**B757 MANUAL SUPPLEMENT - ATP 3510
SECTION 1 CHAPTER 53
CONTROL PAGE - ISSUE 2**

**AIRPLANE
NB322**

TEMPORARY REVISION No. 53-527

Manual Reference 53-12-01 Page 207

Forward Wing/Body Fairing
Figure 401

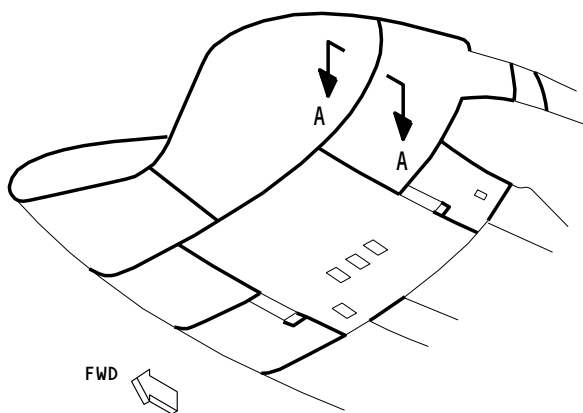
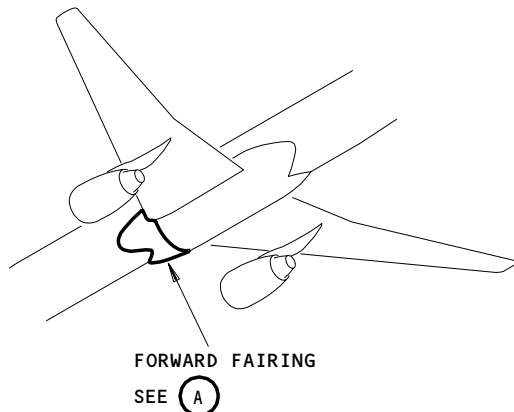
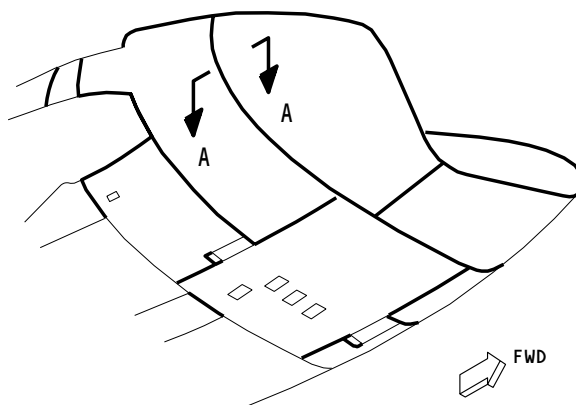
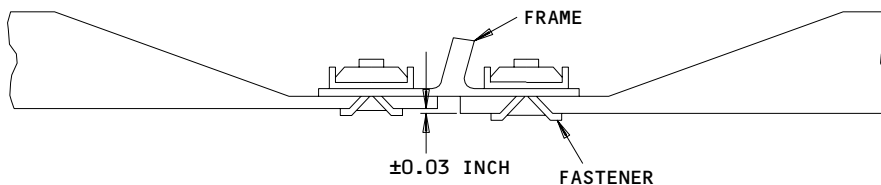
To revise the requirements for wing to body attaching hardware including a run down torque check on nut plates and to detail the installation of fasteners with BMS 5-95 sealant.

(8) Check nut plate serviceability

- (a) Perform a function check of the self locking feature of the fairing panel attachment nut plates. Using torque wrench part No. MHHADS4 or equivalent, accomplish a run down torque check of the locking feature of the fairing panel attachment nut plates.
- (b) Replace the nut plate if any of the following conditions are found.
 - 1) All nut plates which have a run down torque value of less than 5 inch pounds.
 - 2) The nut plate is missing.
 - 3) The nut plate is loose or damaged.
- (c) The number of nut plates to be checked per panel are as follows:
 - 1) All nut plates retaining the leading edge of the panel.
 - 2) Each alternative nut plate other than at the panel leading edge.

(8) Install the fairing to the structure with the fasteners.

(a) Install all fasteners wet with BMS 5-95 sealant, except at stainless steel electrical bonding fastener locations.

(b) Torque the stainless steel (bonding) fasteners to 35-45 lb-in.

(c) Torque the other fasteners to 25-35 lb-in.

(20) Fairing fastener inspection.

(a) Inspect all edges of the fairing panel for missing fasteners, paying particular attention to the leading edge. The following limitations apply.

1) Not more than 1 in 10 fasteners may be missing from the leading edge of the fairing panel.

2) Not more than 1 in 5 fasteners may be missing from all other edges of the fairing panel.

3) Any missing fasteners must be a minimum distance of 5 fasteners apart.

Wing-to-Body Fairing
Figure 401

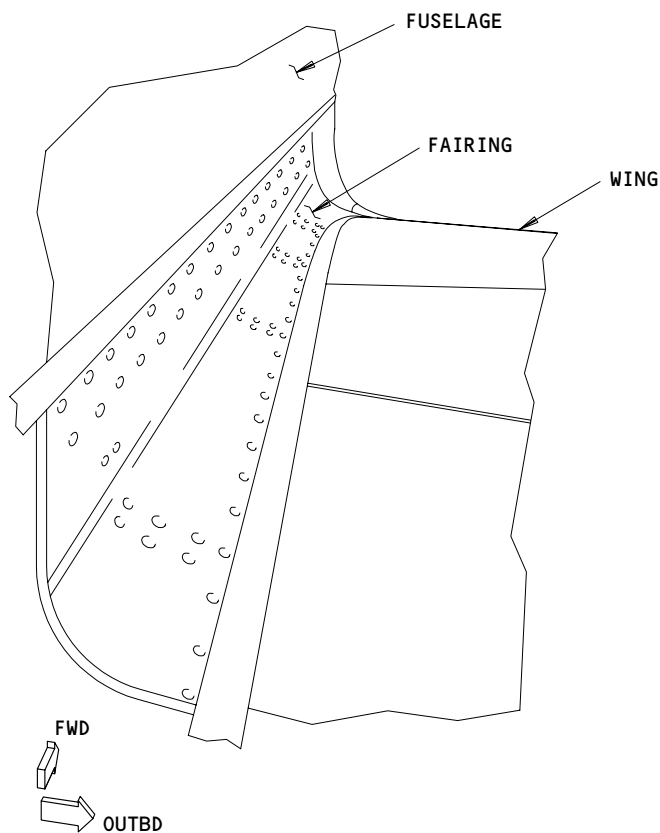
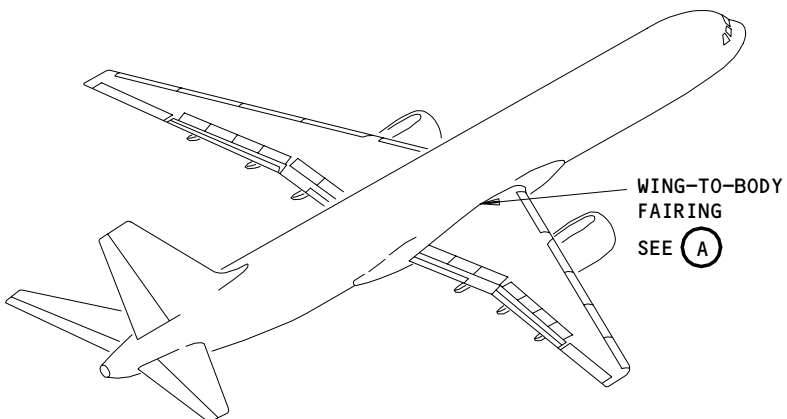
To revise the requirements for wing to body attaching hardware including a run down torque check on nut plates and to detail the installation of fasteners with BMS 5-95 sealant.

(3) Check nut plate serviceability

- (a) Perform a function check of the self locking feature of the fairing panel attachment nut plates.**
Using torque wrench part No. MHHADS4 or equivalent, accomplish a run down torque check of the locking feature of the fairing panel attachment nut plates.
- (b) Replace the nut plate if any of the following conditions are found.**
 - 1) All nut plates which have a run down torque value of less than 5 inch pounds.
 - 2) The nut plate is missing.
 - 3) The nut plate is loose or damaged.
- (c) The number of nut plates to be checked per panel are as follows:**
 - 1) All nut plates retaining the leading edge of the panel.
 - 2) Each alternative nut plate other than at the panel leading edge.

- (2) Align the fairing with the fastener holes and install the bolts and washers.

- (a) Install all fasteners wet with BMS 5-95 sealant, except at stainless steel electrical bonding fastener locations.
- (b) Torque the stainless steel (bonding) fasteners to 35-45 lb-in.
- (c) Torque the other fasteners to 25-35 lb-in.

- (8) Install the fasteners which attach the fairing to the structure.

- (a) Install all fasteners wet with BMS 5-95 sealant, except at stainless steel electrical bonding fastener locations.
- (b) Torque the stainless steel (bonding) fasteners to 35-45 lb-in.
- (c) Torque the other fasteners to 25-35 lb-in.

- (11) Fairing fastener inspection.

- (a) Inspect all edges of the fairing panel for missing fasteners, paying particular attention to the leading edge. The following limitations apply.
 - 1) Not more than 1 in 10 fasteners may be missing from the leading edge of the fairing panel.
 - 2) Not more than 1 in 5 fasteners may be missing from all other edges of the fairing panel.
 - 3) Any missing fasteners must be a minimum distance of 5 fasteners apart.
- (b) If areas of missing fasteners are found, then the appropriate fasteners must be installed.

Aft Wing/Body Fairing
Figure 401

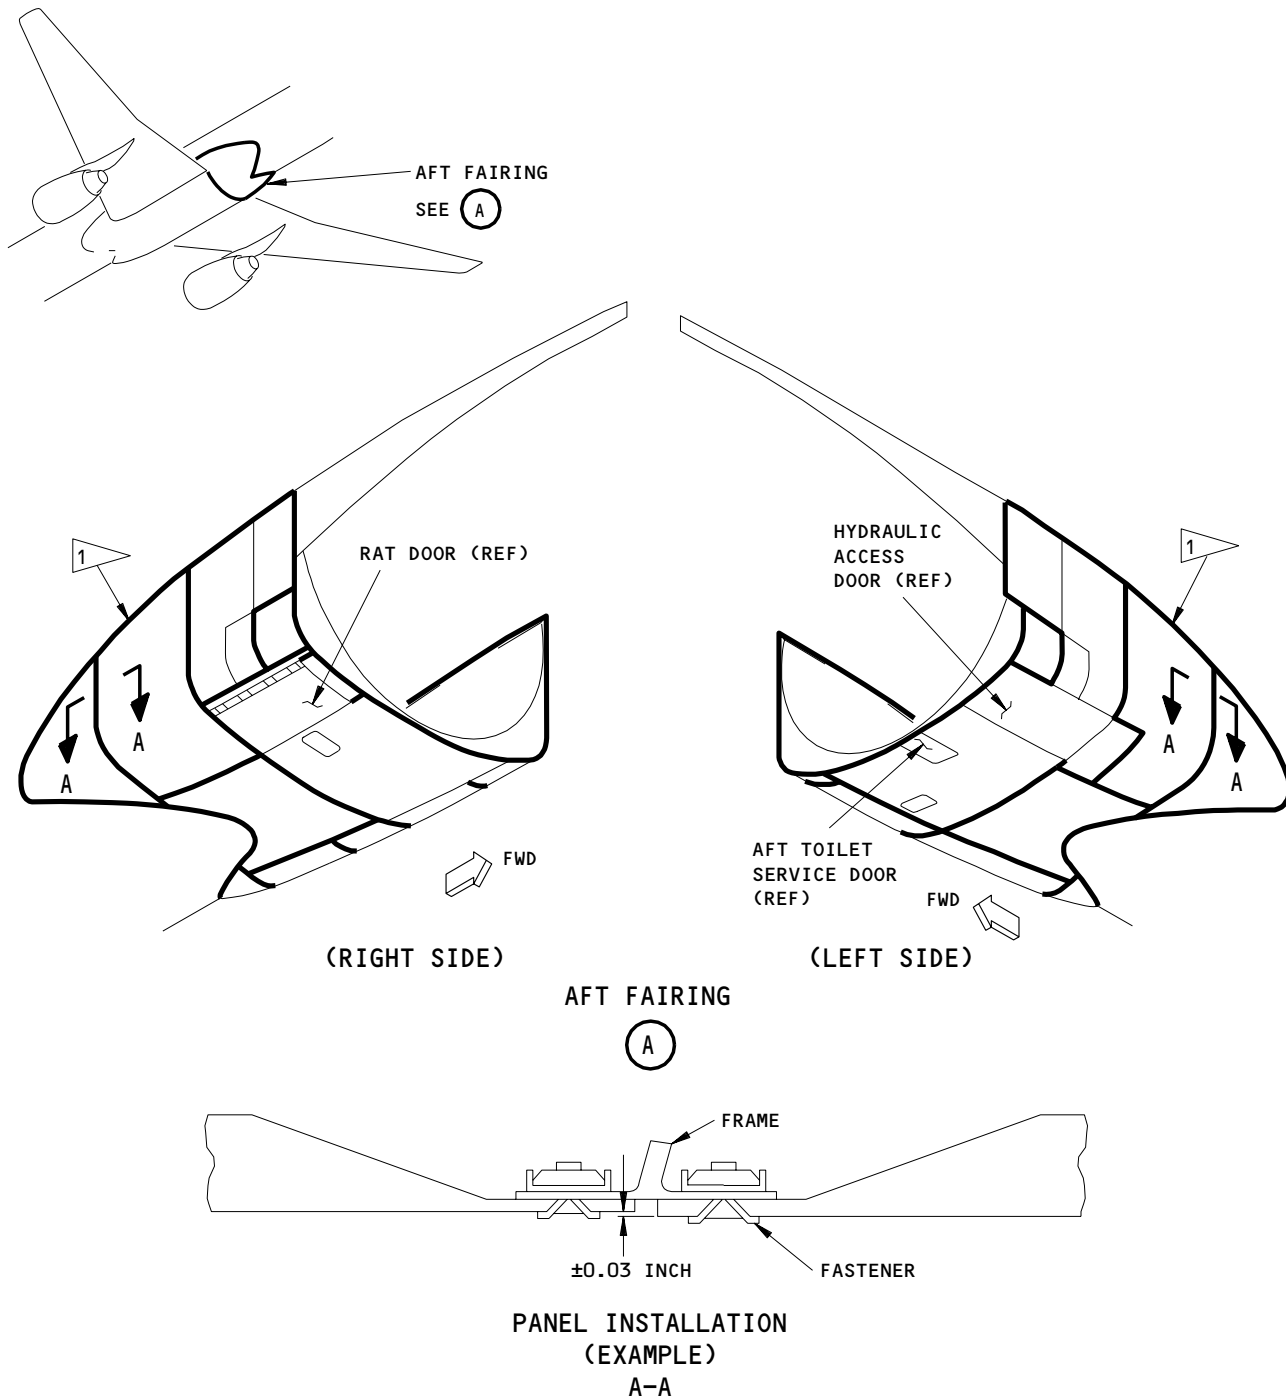
To revise the requirements for wing to body attaching hardware including a run down torque check on nut plates and to detail the installation of fasteners with BMS 5-95 sealant.

B. All the installations of the aft fairing panels are almost the same, except fairing panels 195BL and 196BR on modified aircraft which are installed with 0.25 inch diameter fasteners with a higher installation torque value.

(b) Replace the nut plate if any of the following conditions are found.
